**FINDINGS AND RECOMMENDATION
OFFICE OF PLANNING AND ZONING
ANNE ARUNDEL COUNTY, MARYLAND**

CASE NUMBER: 2024-0010-V

HEARING DATE: April 2, 2024

REQUEST

SITE PLAN
SCALE: 1" = 10'

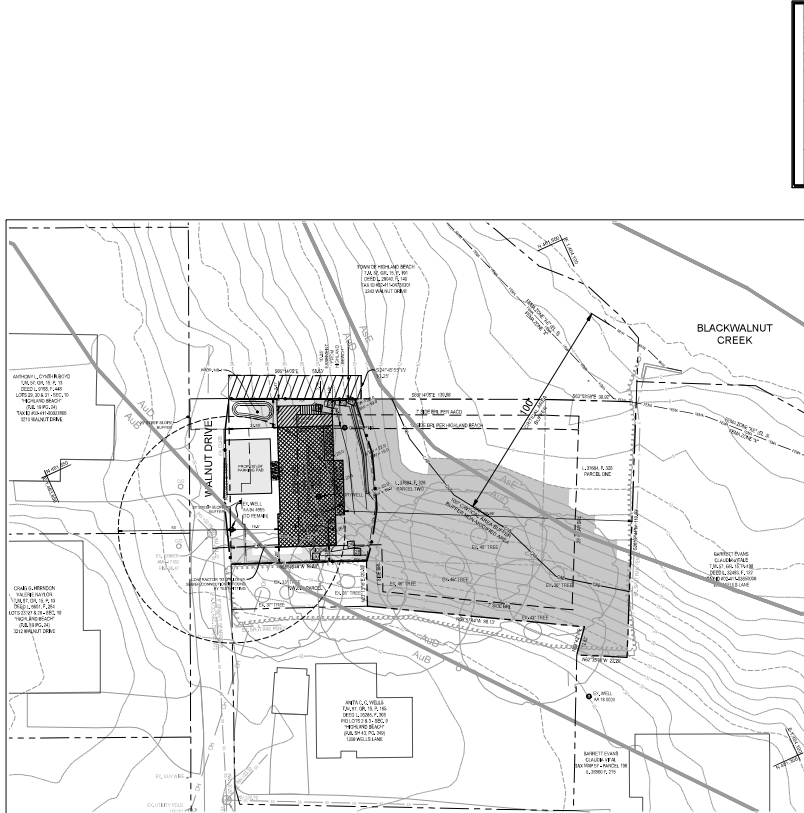
The proposed plans show a retaining wall to the east of the property on the steep slopes. The applicant should consider other, non-structural alternatives to slope stabilization, such as deep-rooted plantings of shrubs and herbaceous plants. Addressing the cause of any upland erosion will also help stabilize the steep slopes on the property.

The proposed plans include adding a cantilever deck on the east side of the dwelling and an elevated deck on the northside of the dwelling. While both structures do not count towards lot coverage, they do increase disturbance to the expanded Buffer and steep slopes, and are not the minimum necessary to afford relief, as specified in Anne Arundel County Code 18-16-305(c)(1).

Comments
Variance comments
2024-0010-V 3205 WALNUT DR
1. A Micro Bio is proposed within a steep slope/steep slope buffer. SWM facilities shall not be located in areas that are off-limits to development, e.g., natural resource areas and their buffers. Please clarify.

2. All infiltration/filtration devices shall be located a minimum of 25 feet from the top of slopes 25%.
3. Given the disturbance to sensitive resources including the steep slopes and buffers, the proposed design adversely affects the water quality within the Critical Area. Please clarify.

4. Please verify that all of the proposed impervious surfaces are treated for water quality.
5. A soil boring is required per practice. The suitability, and siting of proposed SWM practices should be reviewed. Soil boring information including verification of the suitability of in-situ soils for infiltration shall be submitted.

6. Please review existing vegetation (or lack thereof) within the steep slopes; opportunities to supplement vegetation or replanting buffers with native vegetation should be provided to enhance water quality.

7. The County Stormwater manual requires that Infiltration devices uphill from buildings and structures with basements shall be located a minimum of 20 feet from the structure, or the intersection of the structure foundation footing with the phreatic line from the overflow depth of the device, whichever is greater. Please clarify how this requirement is met.

10. Additional information is required to show how the site meets Environmental Site Design.
11. The stormwater management, utility/Engineering design review approval for the site shall occur at the grading permit stage.

12. Based on the provided information, this office does not support this request.
